CELL MANUFACTURING QUALITY CHECKS

Key Messages

RUN #1 CELLS – CYCLE LIFE TEST

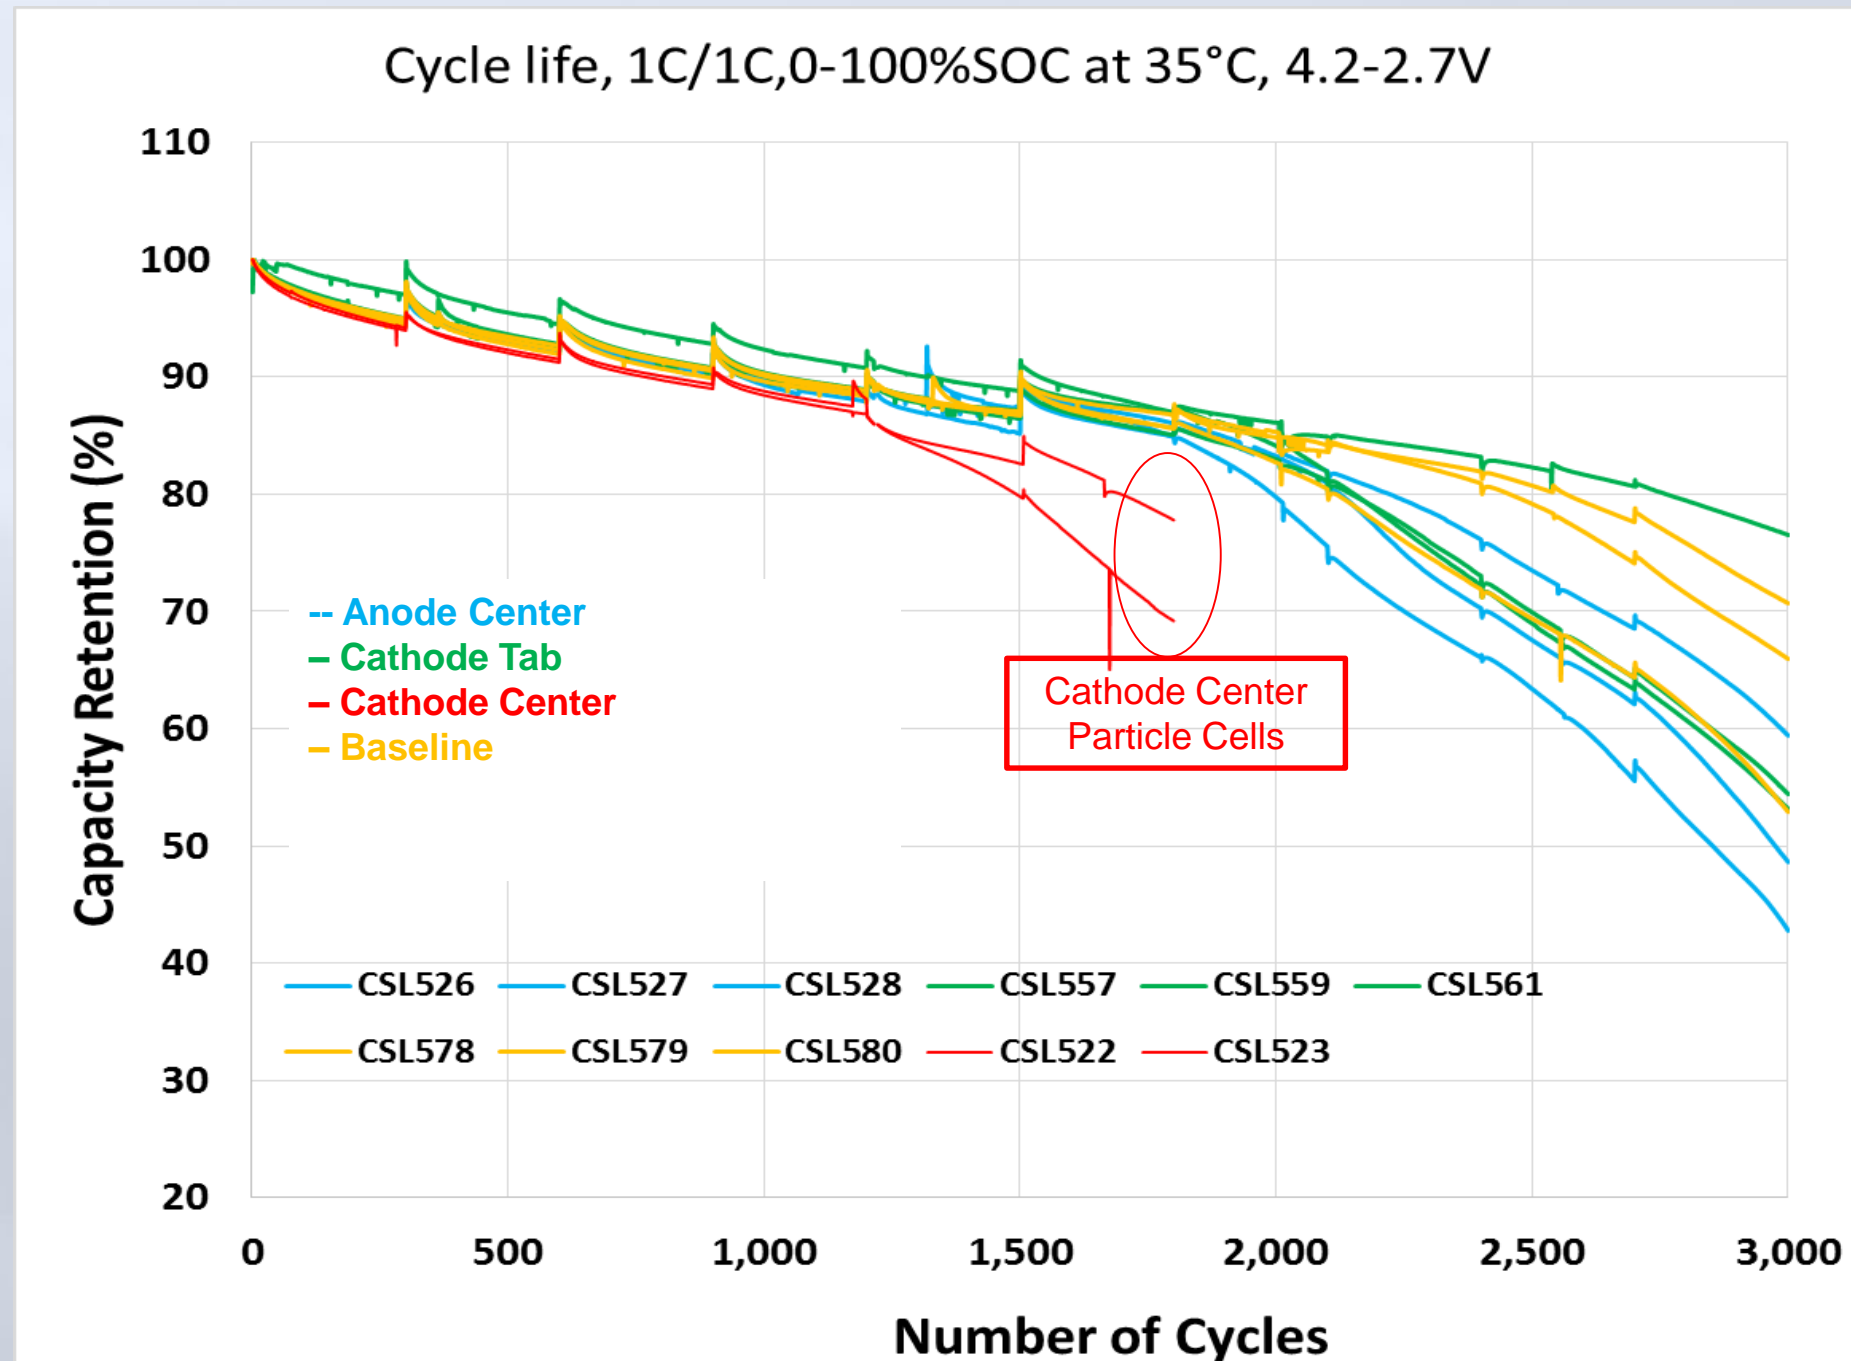
Notice again how a foreign particle introduction can last for many high rate cycles (1C/1C) without failure compared to baseline. When will failure occur?

Were cells under pressure similar to pack designs?
or no pressure?
Your cycling was at 1C rates with no CV at top of
charge (different than vehicles), Did you verify other
rates or CV charging?

Fig. 9.9 The Safe Zone construct

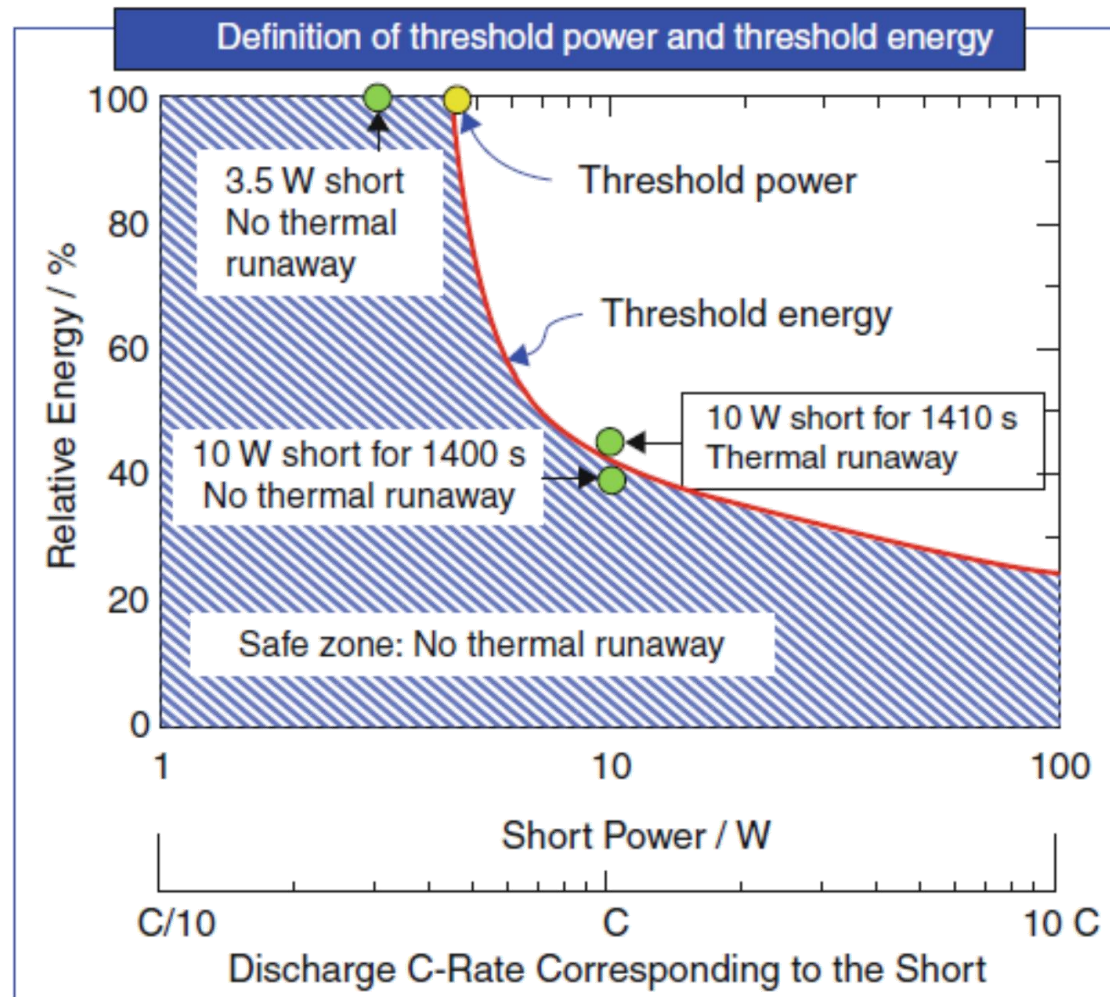
Please expand on this graph? where are chemistry/design and application shown? If just illustrative ok, but not clear. In my view this will be different for every cell. The axes are misleading. Safe zones for 18650s are not the same as for EV cells.
